**GFA AD 483**  
(ISSUE 1)

### GFA AIRWORTHINESS DIRECTIVE

**TYPE AFFECTED:** PW-5 Smyk

**SUBJECT:** Miscellaneous Service Bulletins.

FIGURE 1 CANOPY HANDLE REPLACEMENT

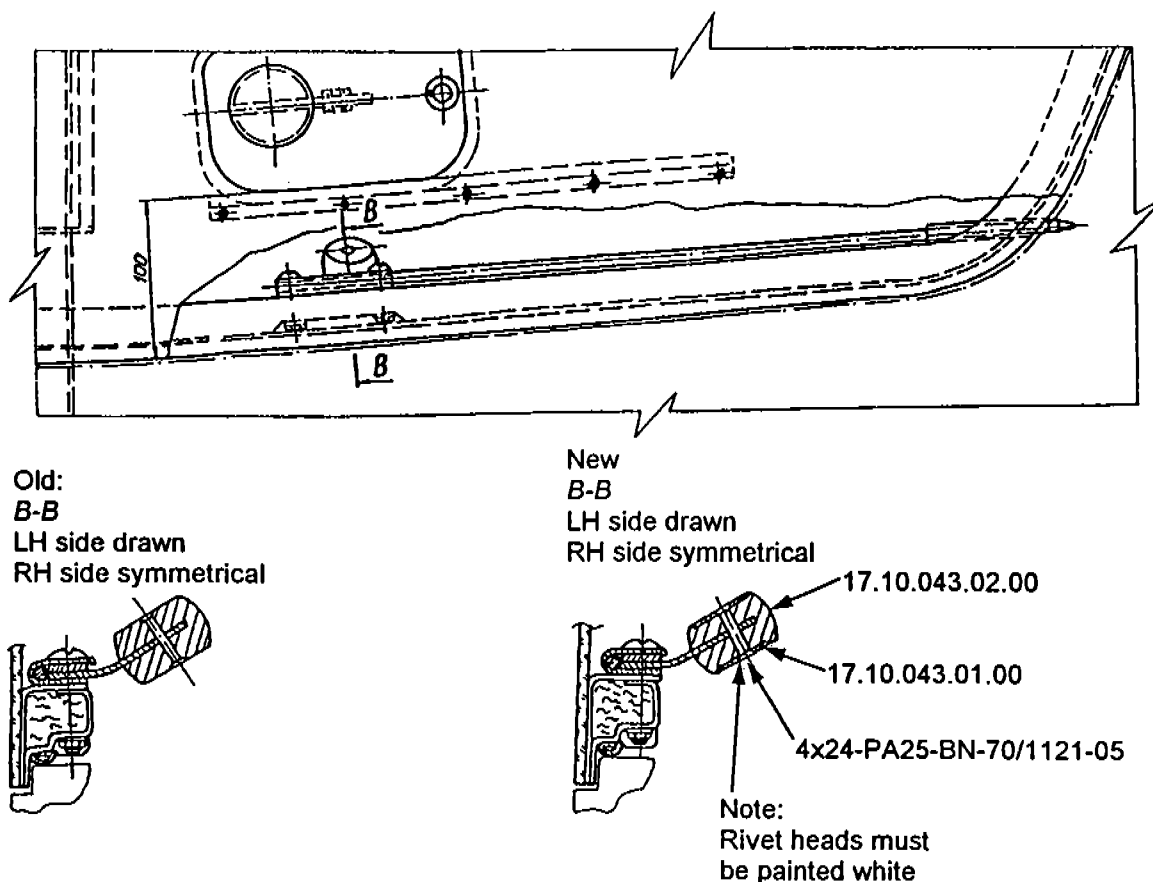
4. At the next Annual Inspection after 30 September, 1998 the canopy locking handles must be replaced on serial numbers up to 17.08.018 (except S/N 17.08.011). The new handles must be installed in accordance with Figure 1. Parts must be obtained from the manufacturer.

Sketch 2

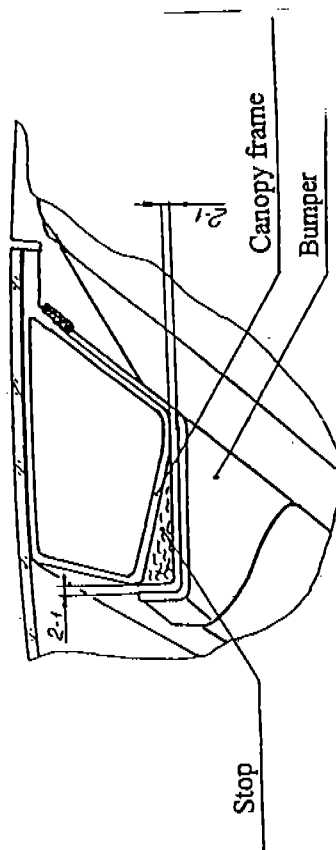
Improve the shape of the rear part of the canopy frame (within the plane of symmetry over the length of overlapping beyond the bumper in the fuselage), making a stop by application a layer of the EP-53+Z1 compound with admixture of flock and carbon black - refer to Sketch 2. When applying, maintain a smooth pathway between the stop and canopy frame.

Sketch 1

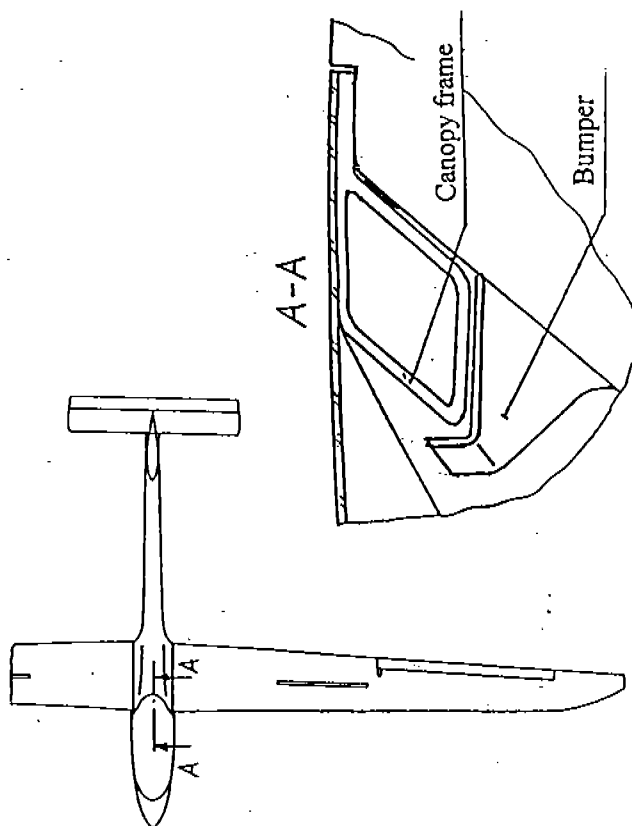
Due to several cases of improper shape of the PW-5 glider canopy frame profile as compared with the design documentation which results in mismatching of the canopy frame and fuselage bumper, proceed as follows:

Carry out a single inspection of the mating components for technical condition and make sure whether the canopy frame overlaps the bumper as shown on Sketch 1.
